ADDENDUM #2
CITY HALL REMODEL
BID # 20/21-008 / PWP # WA-2021-135
BIDS DUE NO LATER THAN: 1:45 PM ON FEBRUARY 17, 2021 - REVISED
PUBLIC BID OPENING: 2:00 PM ON FEBRUARY 17, 2021 - REVISED

This addendum is to notify all potential proposers of clarifications made to the Bid documents as stated below.

RFI Questions and Answers:

I.T. OFFICES - PLANS, SECTIONS, ELEVATIONS

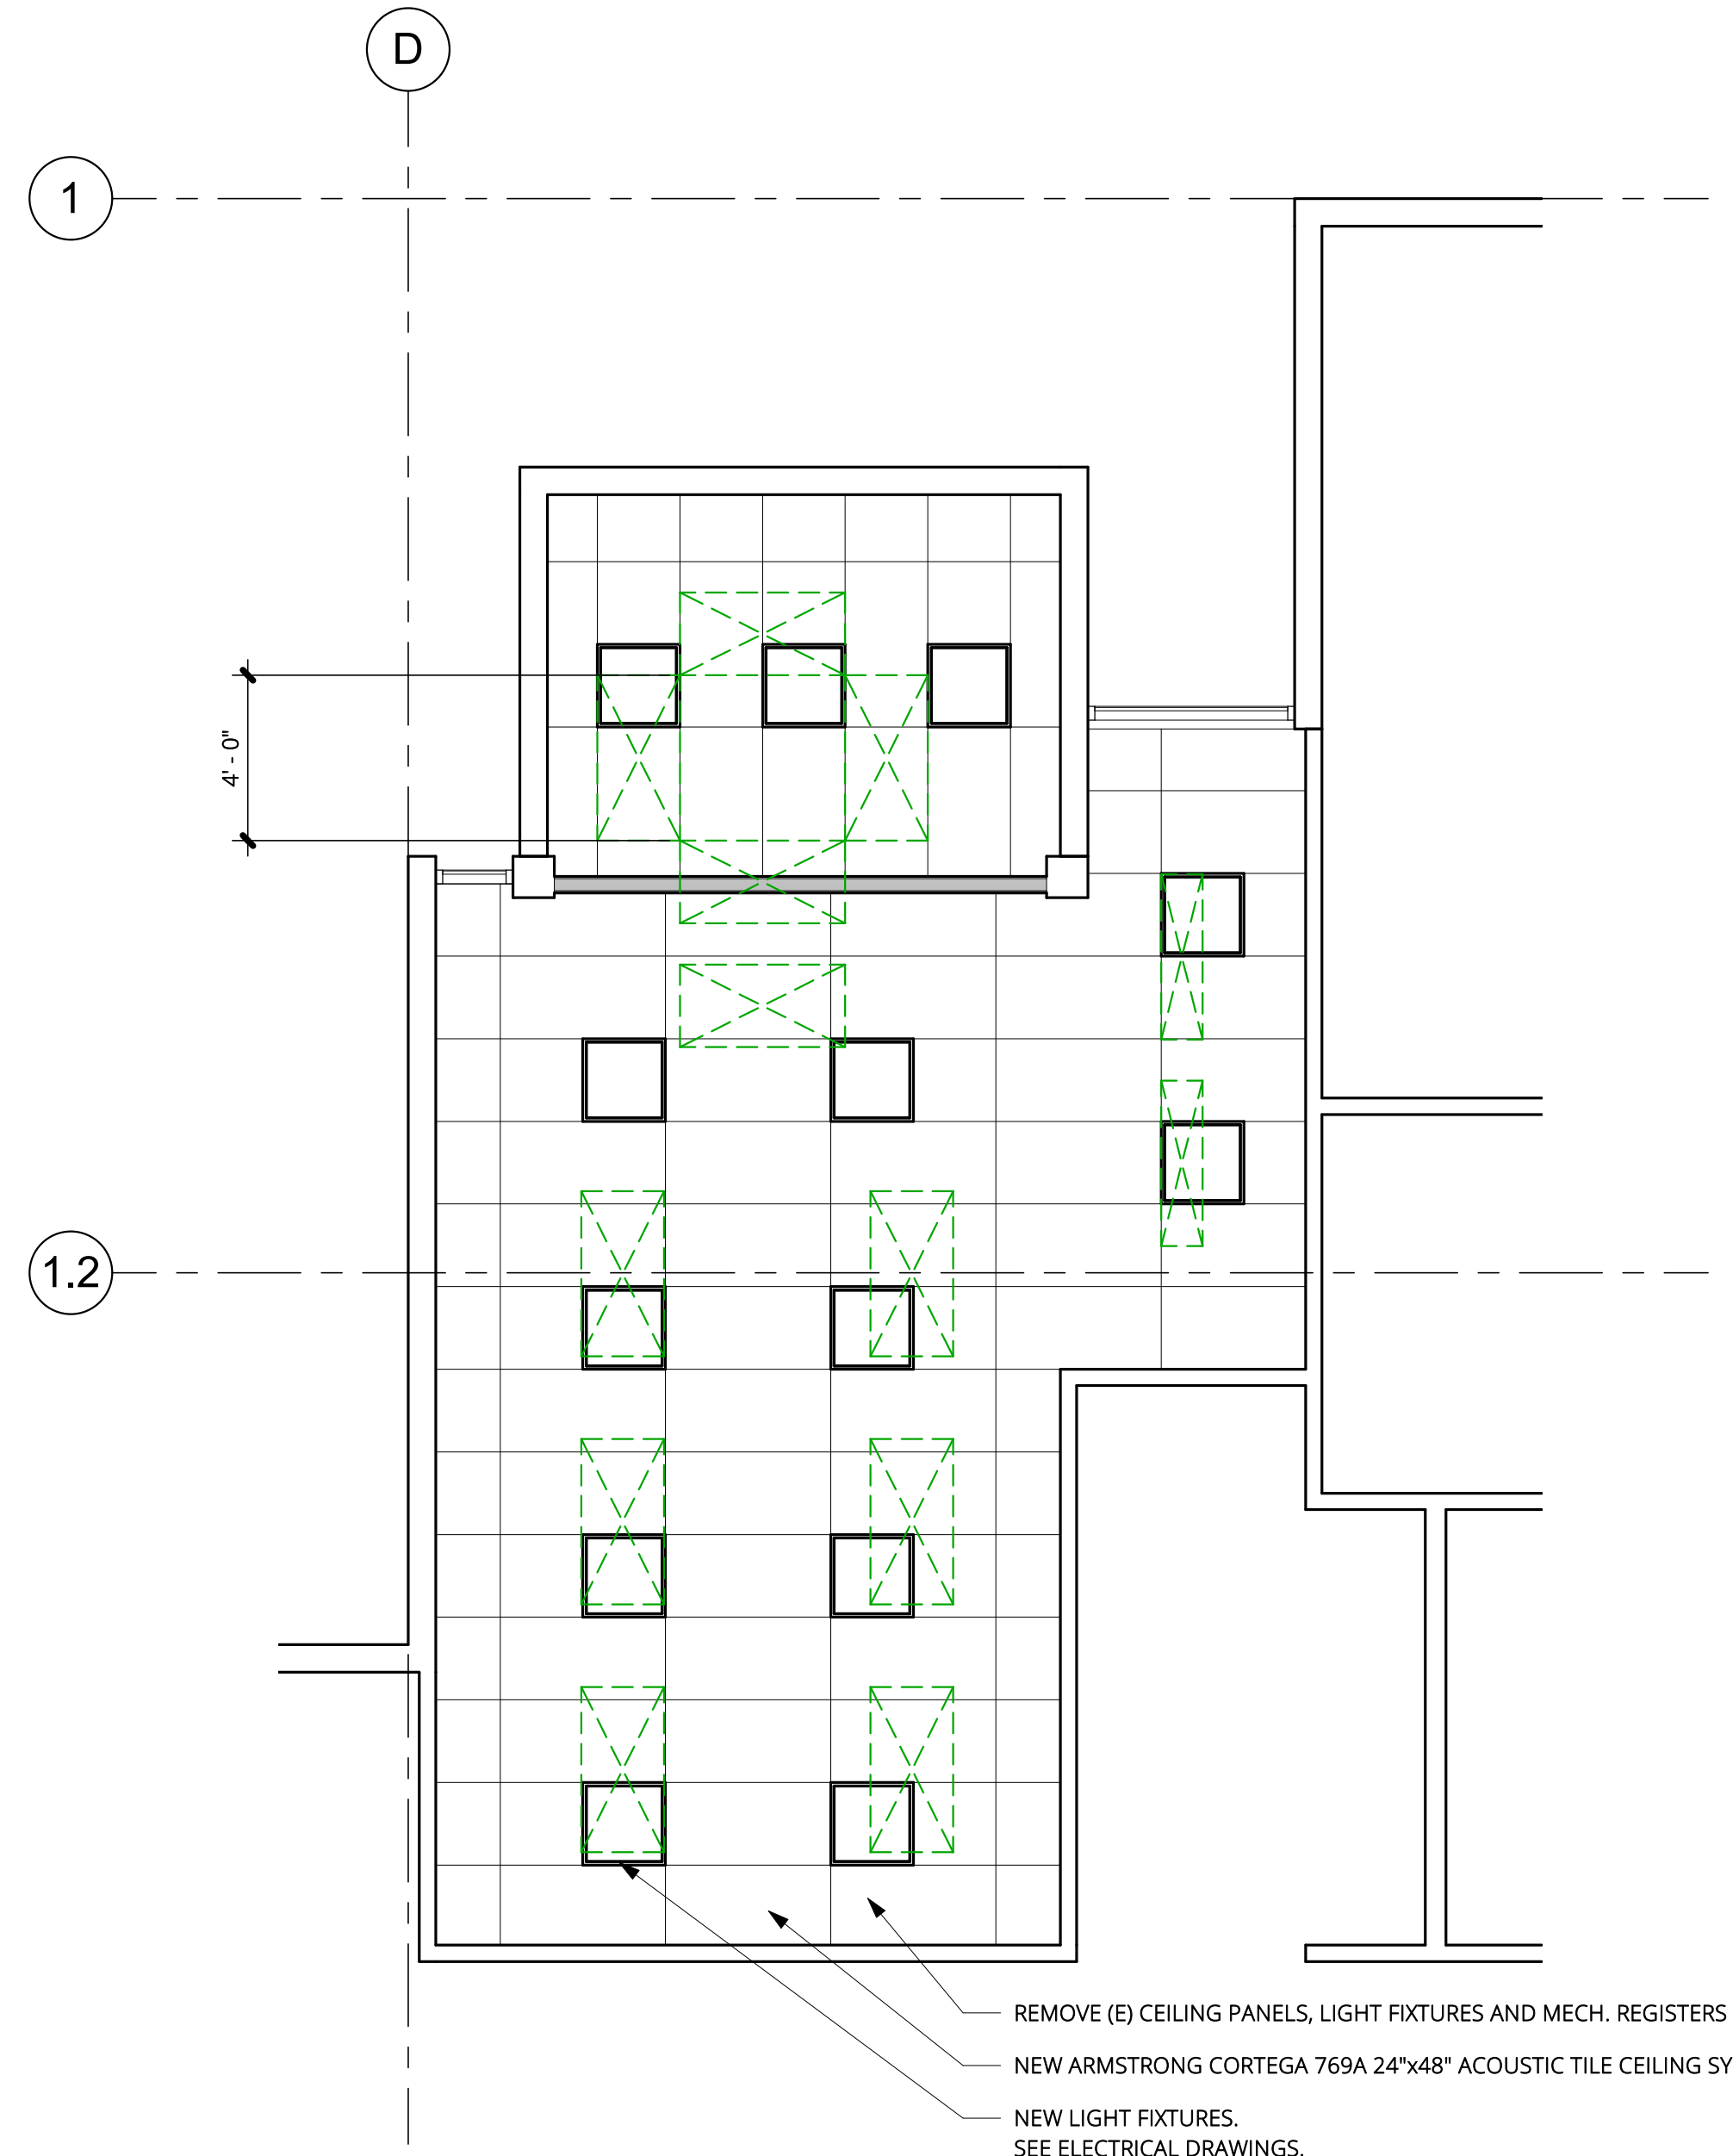
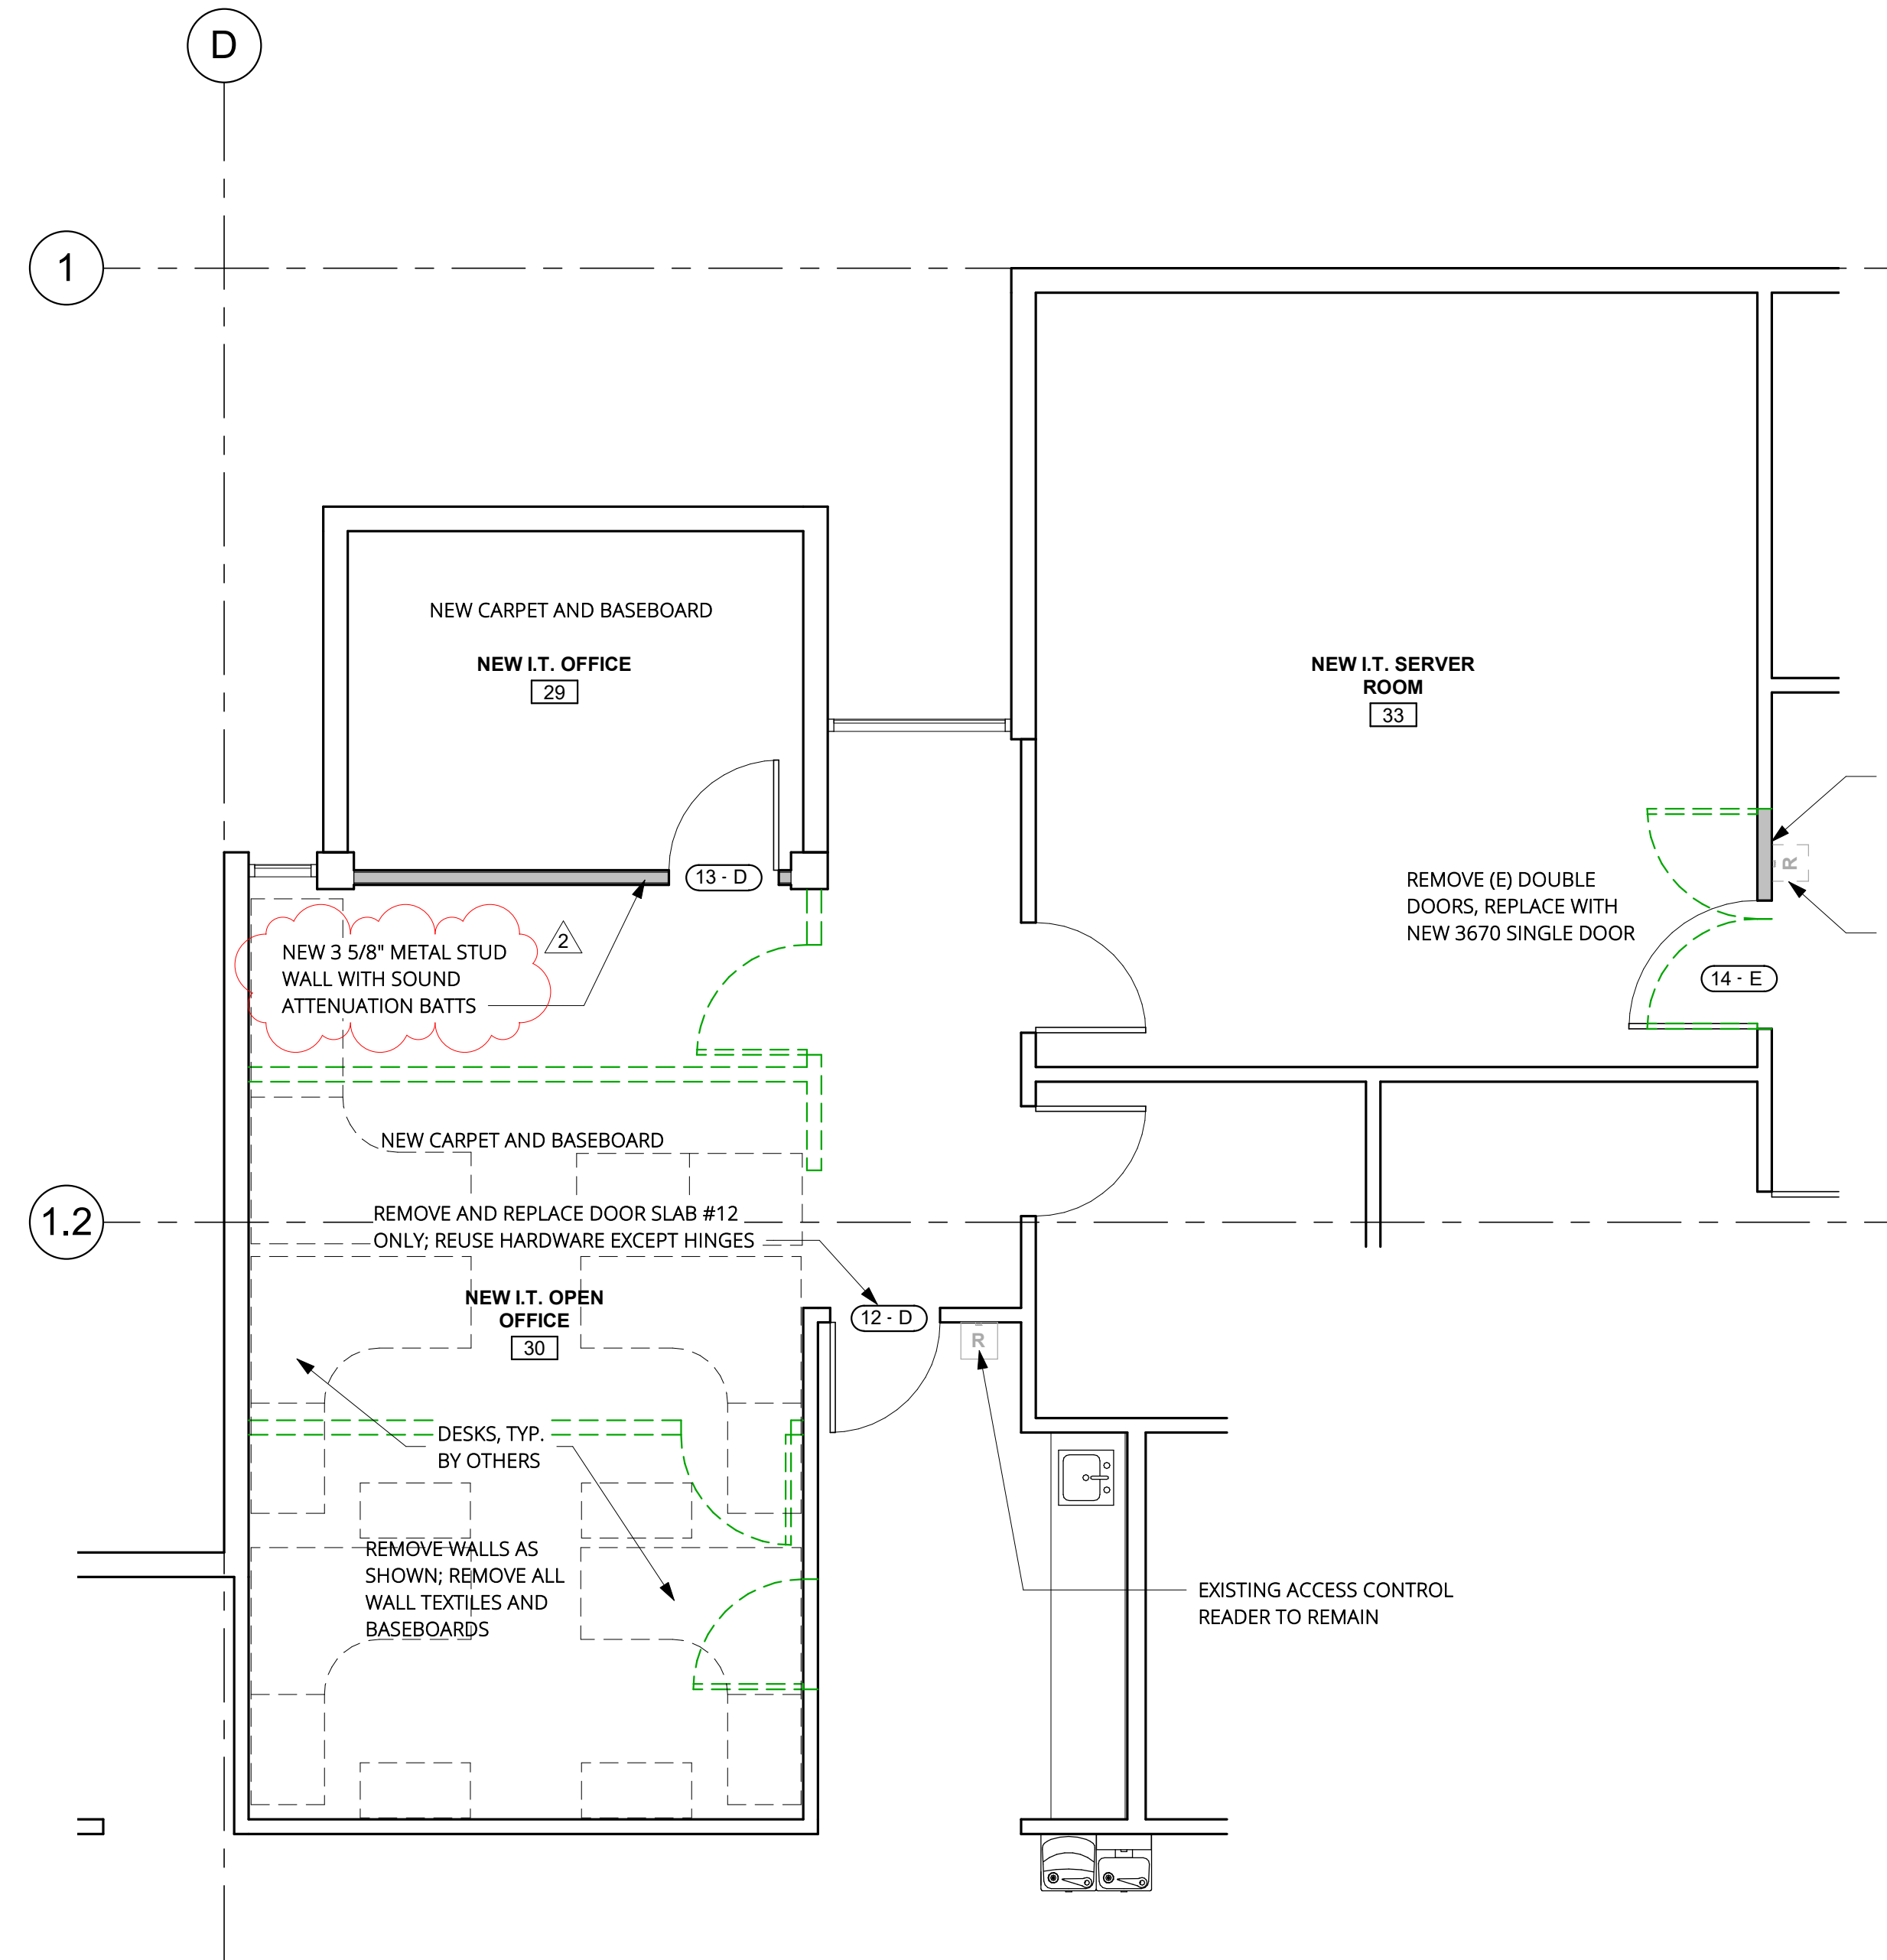
Sheet a204 New IT Office #209 calls for a 2x4 wall, the Wall Legend calls for new walls to be 3 5/8" metal studs. Is this wall to be a 2x4 wood stud or 3 5/8" metal stud wall?

- i) **Answer:** All new walls shall be constructed of 20 gauge 3 5/8" metal studs unless noted otherwise. All references to wood studs have been updated on the attached plans to reference metal studs. See attached revised plans.
